## 3873A Central Somers Town, Phase 2, Plots 5&6

### Items Proposed

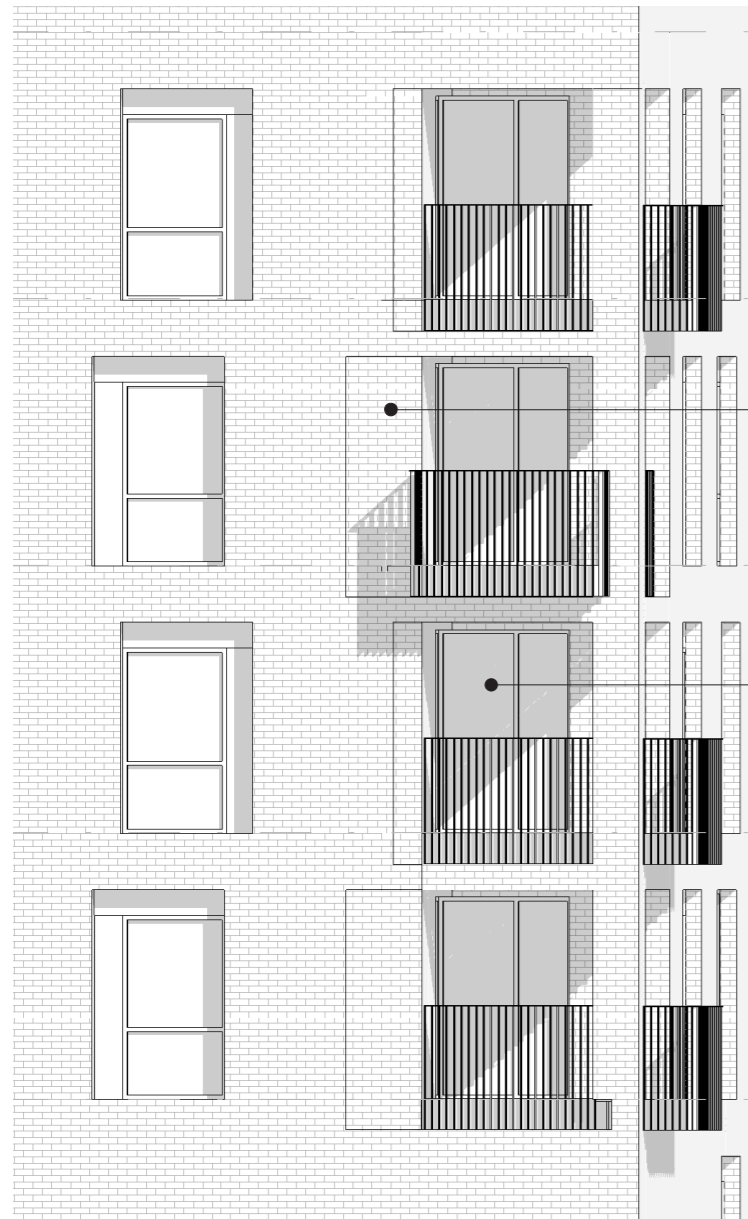
- Item 01 - Change brick coping to metal coping. Colour to match brickwork

Brick coping changed to metal coping

**Metal Coping**

Plot 5 - RAL 3012

Plot 6 - RAL 3009

(to be confirmed through samples)

Wall build-up

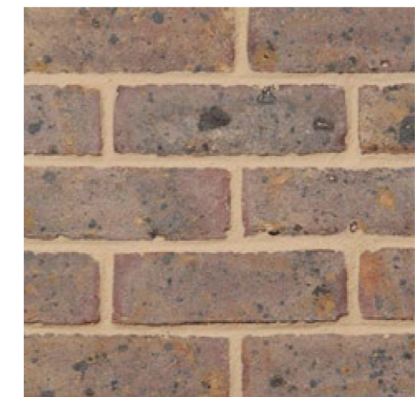
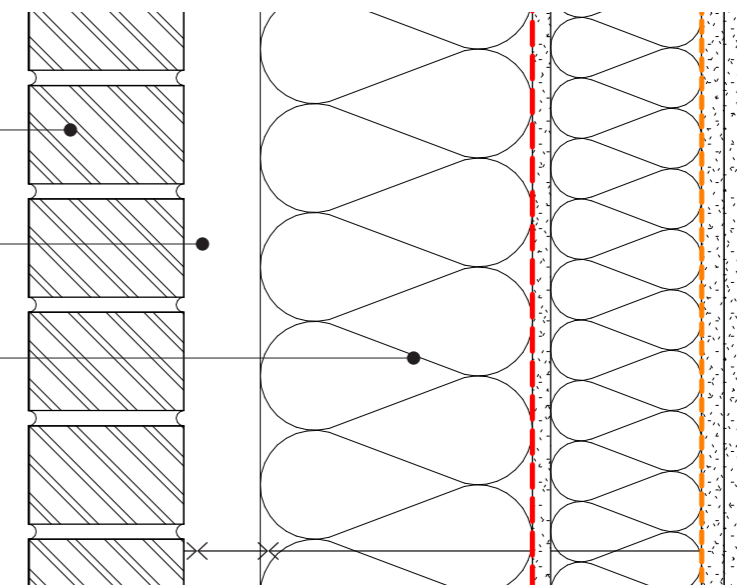
- Item 02 - Change metal rainscreen panels around inset balconies to brickwork panels flush with main facing brickwork with contrasting colour

Flush brickwork panel  
Bricks to contrast in colour with general building brickwork

Windows moved together at rear of balcony

Brick colour to be chosen from current project palette

Facing brick in contrasting colour

Drained cavity

Insulation/waterproofing and structure as per the rest of the facade

Section showing light reflecting into lower ground flat

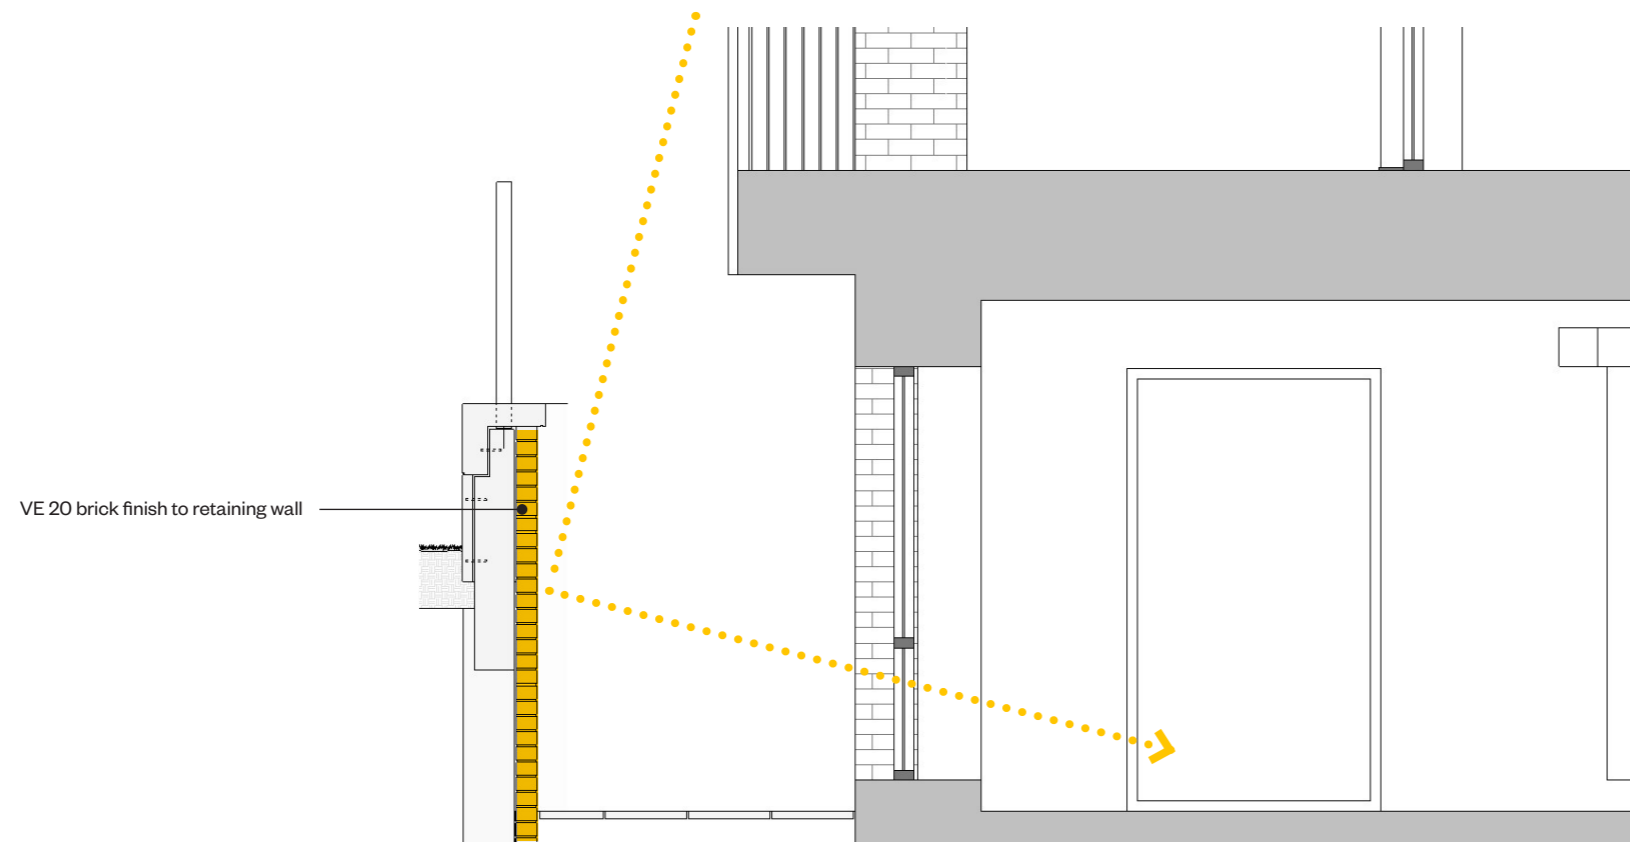
- Item 03 - Removal of glazed bricks to retaining wall and replace with white brick

- Planning
  - Block B - S2.B - Freshfield Lane 'First Quality Multi-Facing' bricks.
  - Block C - S2.C - Freshfield Lane 'Selected Dark Facing' bricks
  - Inside finish for surround retaining wall for both Block B&C - S3 - White glazed facing brickwork
- Proposal
  - Inside finish 'S3' for surround retaining wall for both Block B&C - Porcelain White Smooth, Brockley, Michelmersh or similar
  - Retain material quality by replacing glazed brick with a more cost effective white brick and light mortar to maximise daylight levels into lower ground flats at the lightwells

White brick

Example 600x600mm tile layout for Type 1 balcony

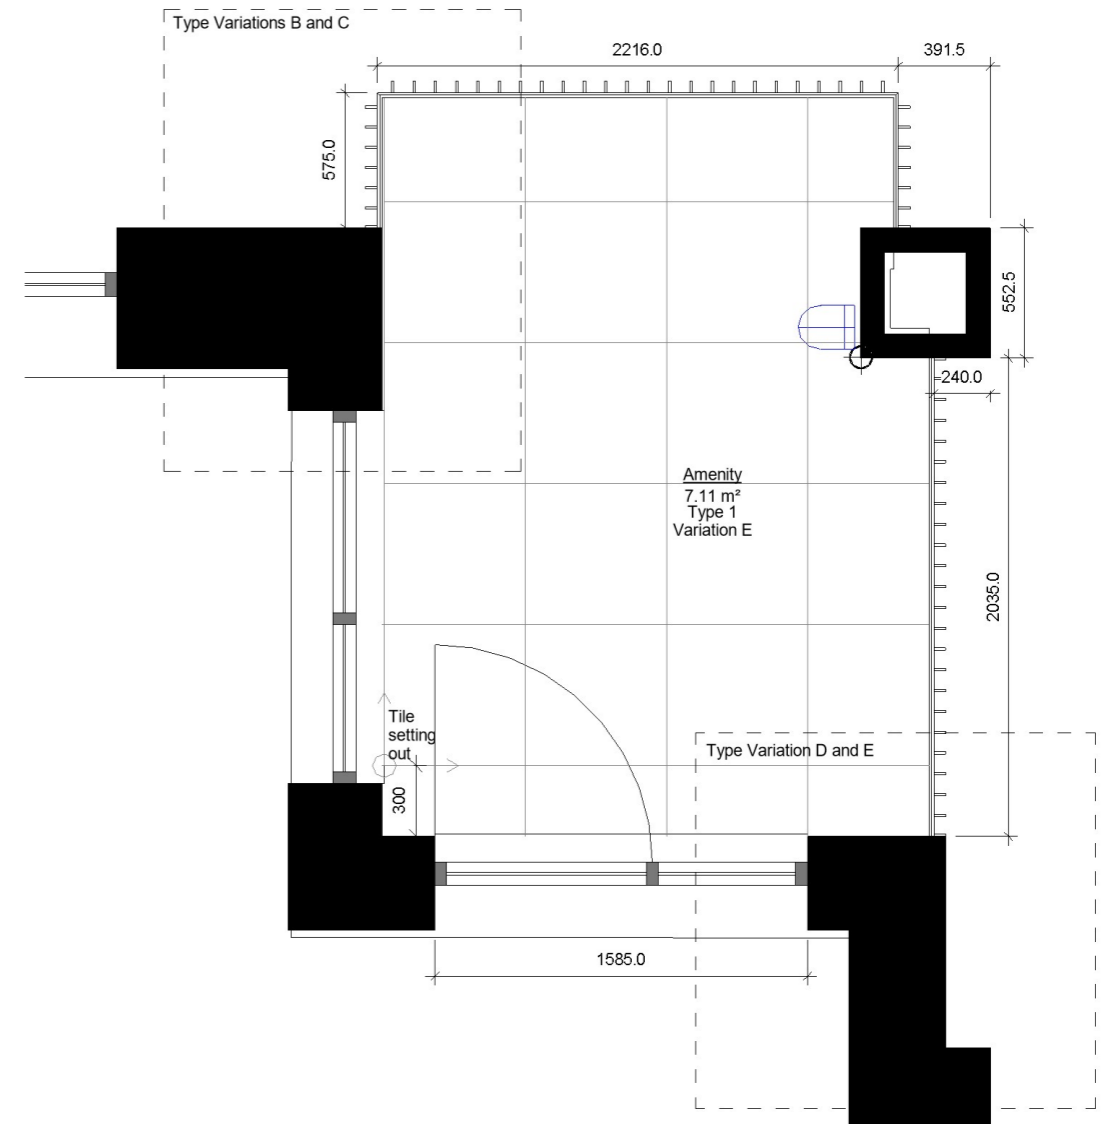
- Item 04 - Metal decking on balconies changed to paving slabs.
- 20x600x600mm porcelain tile
- Parkside Architectural Tiles. Range Elvert or Wickliff
- Colour choice:
  - Elvert range 'Sand'
  - Wickliff range 'Cement'

Elvert Sand - 600x600x20mm

Wickliff Cement - 600x600x20mm

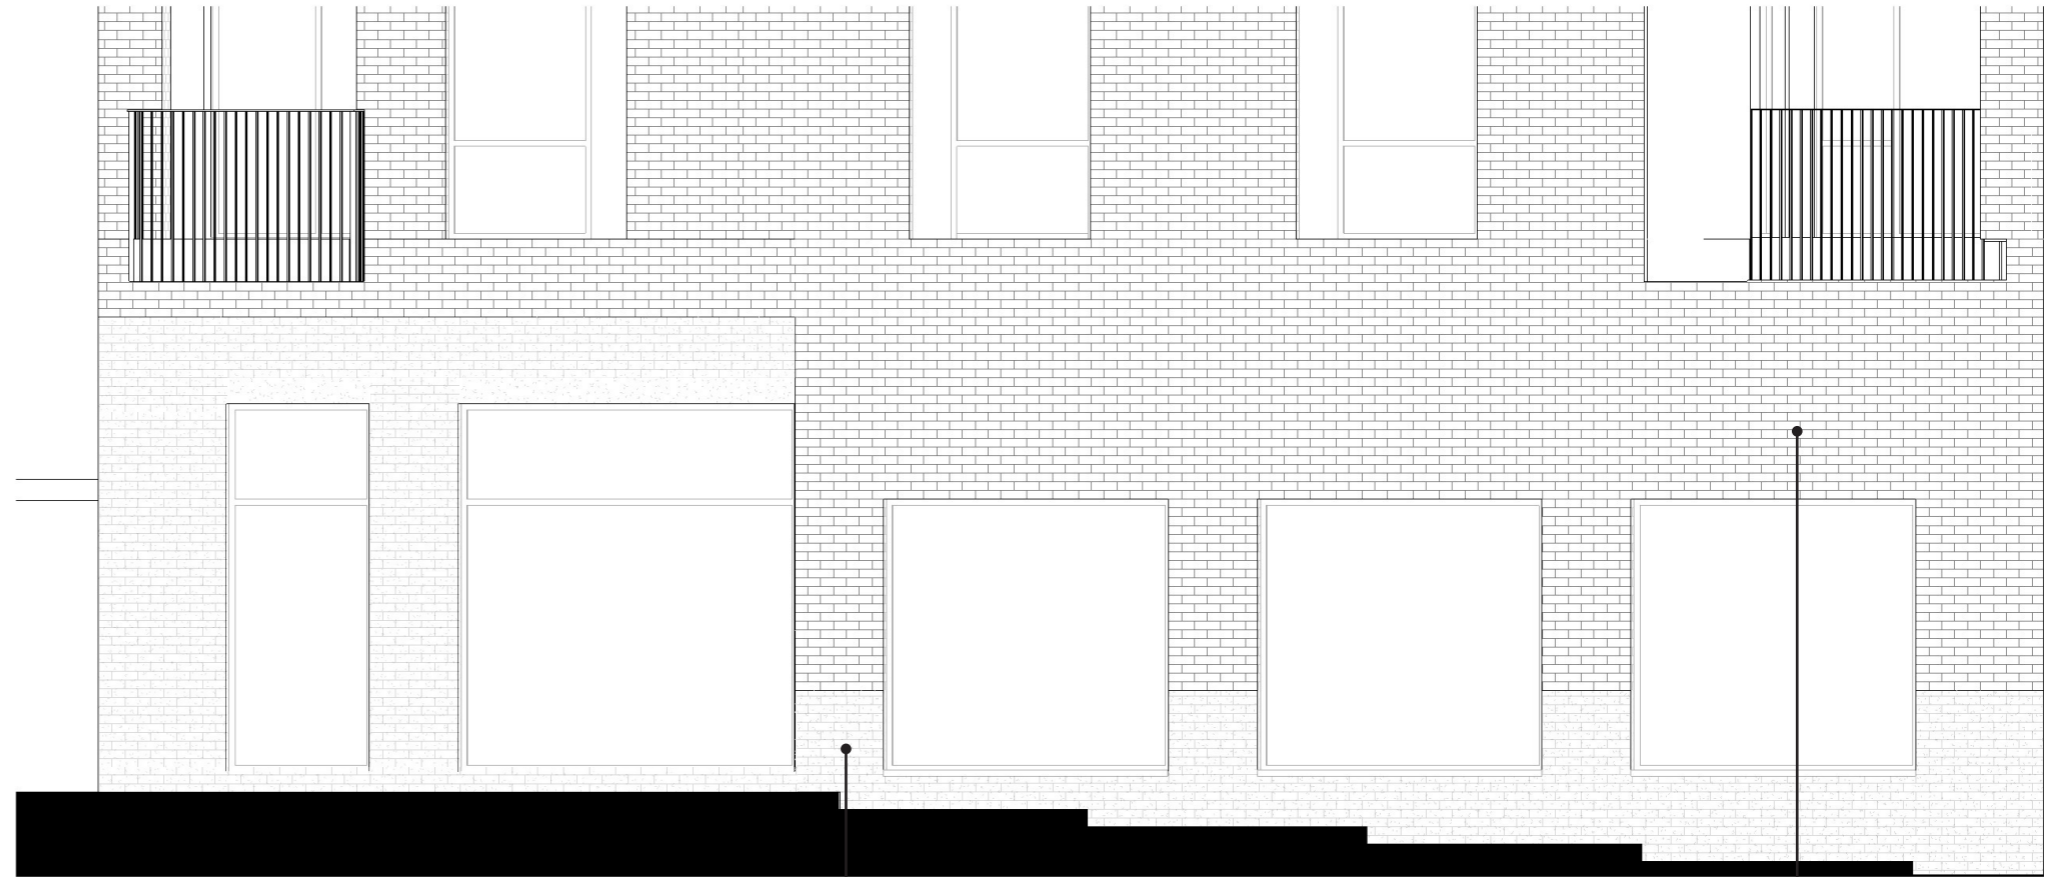
- Item 05 - Replace concrete finish around Community Hall with Freshfield Yellow Multi, a lighter brick with hints of pink to reflect more light similar to the original materiality.
- Brick specification complements predominant brick type for Block B, Freshfield Lane 'First Quality Multi-Facing' bricks

**Current specification**  
S6.B - external façade - red pigmented, acid etched, partially exposed aggregate precast concrete panel cladding system

Plinth and community entrance in a Freshfield Yellow Multi
